Response to Second NRC Request for Additional Information

ANP-10326Q2NP
Revision 0

ANP-10326NP, Revision 1,
Environmentally Assisted Fatigue: Modified
Effective Correction Factor for Austenitic
Stainless Steels

May 2015

Figure 1-1 AREVA autoclave system for fatigue tests in water

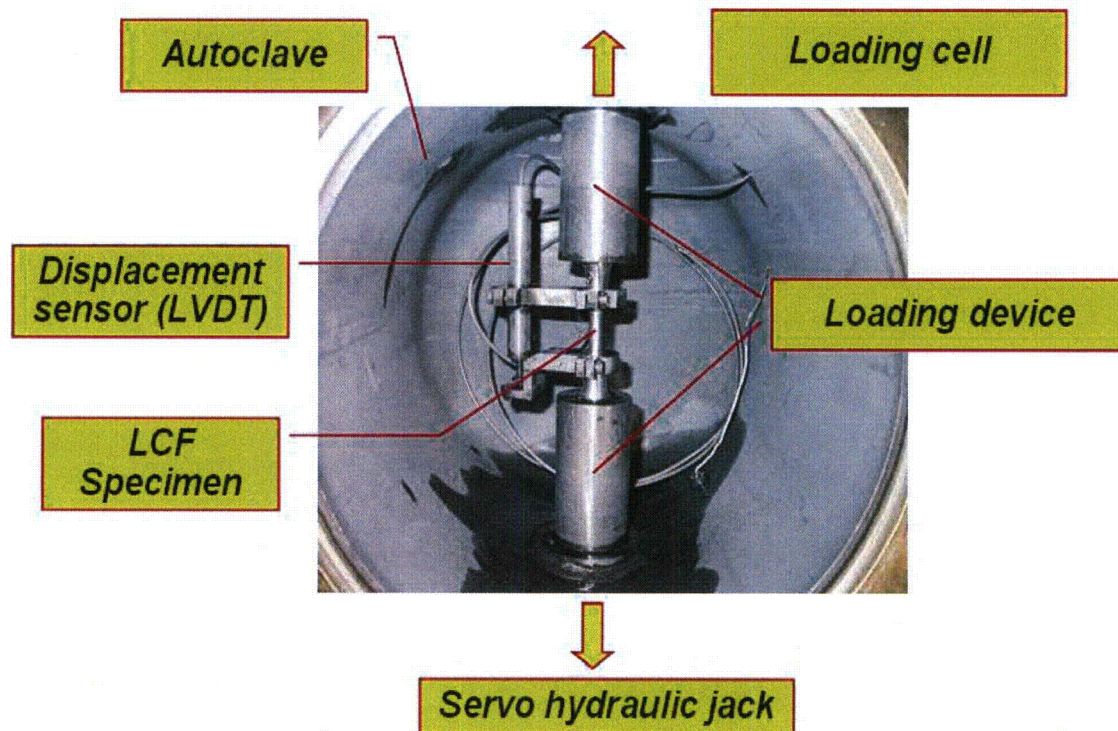
- a. Summarize the air and water test procedures used and identify if any standardized test procedures (i.e., ASTM) were utilized.
- b. Page 3-17 describes the procedures used to control the applied strain amplitude. Describe the types, location, and orientation of the strain gages used and how the strain amplitude was recorded and verified.

- b. The AREVA Low Cycle Fatigue (LCF) tests in the PWR environment were performed under axial displacement control by using a Linear Variable Differential Transformer (LVDT) extensometer attached to flanges machined on specimen shoulders. The LVDT extensometer is located inside the autoclave, as Figure 1-1 shows. As an example, for the application of $\pm 0.6\%$ strain amplitude a displacement of $\pm 140\mu\text{m}$ between the flanges is imposed. A standardized MTS automated system (software and program) is used to control the LVDT and thus to impose and record the displacement.

Figure 2-1 Fatigue life for materials with a stable behavior or with a stabilized behavior after hardening

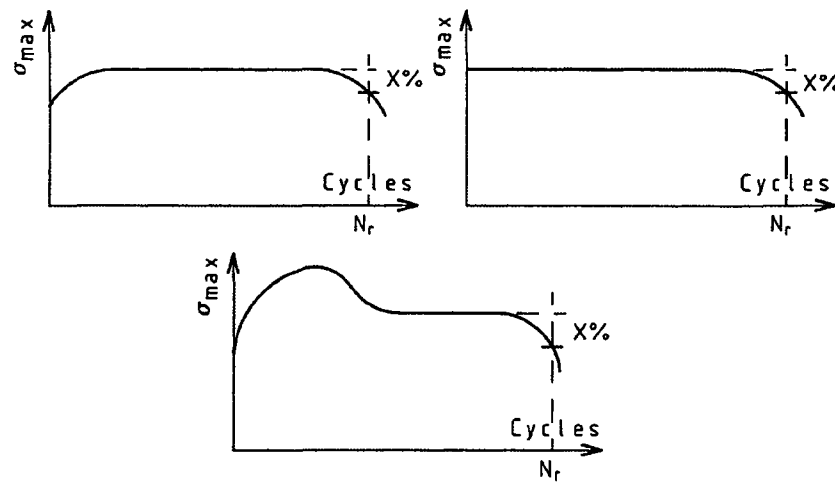
The last sentence on page 3-1 of ANP-10326P, Revision 1, states "This number of cycles typically produces an approximately 3mm-deep crack in the test specimen." The staff is concerned that strain data from these specimens may be inaccurate if cracks developed on the opposite side of the specimen from the strain gage. Describe how this potential situation was addressed, if applicable, and justify any use of data from such specimens, including pictures from representative cracks as appropriate.

The reported in ANP-10326P, Revision 1 cycles to failure, N_{25} , correspond to cycles for the tensile stress, σ_{max} , to decrease to 25% from its peak or steady-state value, as a result of the propagation of the main fatigue crack. Usually, this number of cycles produces in the test specimen approximately a 3 mm deep crack. Figures 2-1 and 2-2 are an excerpt from Reference 1, where $X = 25\%$ and $r = 25$. The first figure addresses materials with a stable behavior or with a stabilized behavior after hardening. Figure 2-2 shows a material with a continuous softening behavior.

Figure 6-1 Specimen dimensions for the in-PWR environment LCF testing, (a) in inches and (b) in mm

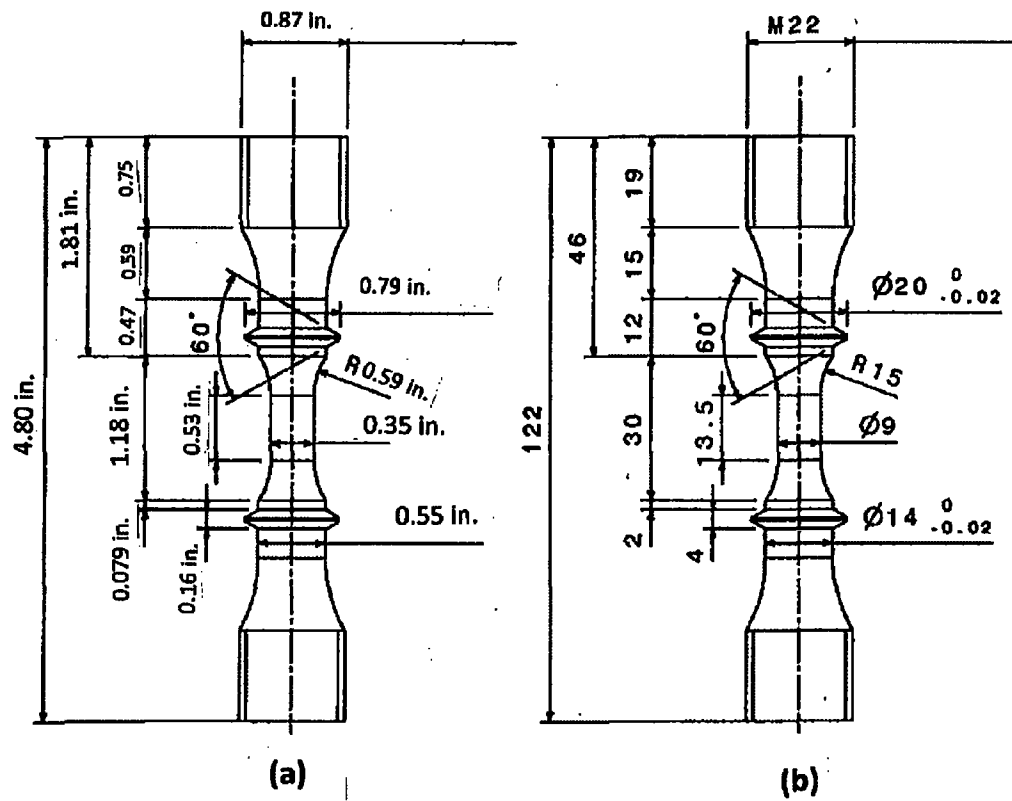
Figure 3-8 of ANP-10326P, Revision 1 shows the specimen geometry used by AREVA for the in-PWR environment fatigue tests, but does not include diameter (or wall thickness, if the specimens are hollow) as was provided in Figure 3-6 for the in-air environment. Provide a revised figure with this information.

All of the in-PWR and in-air tested specimens are solid. The specimen gages for both the in-air and in-PWR specimens are exactly the same (13.5 mm length and 9 mm diameter) to allow for a direct comparison of the fatigue test results. Figure 6-1 provides the dimensions for the specimens tested in a PWR environment. For the revised Figure 3-8 of ANP-10326P, Revision 1, see the enclosed mark-up.
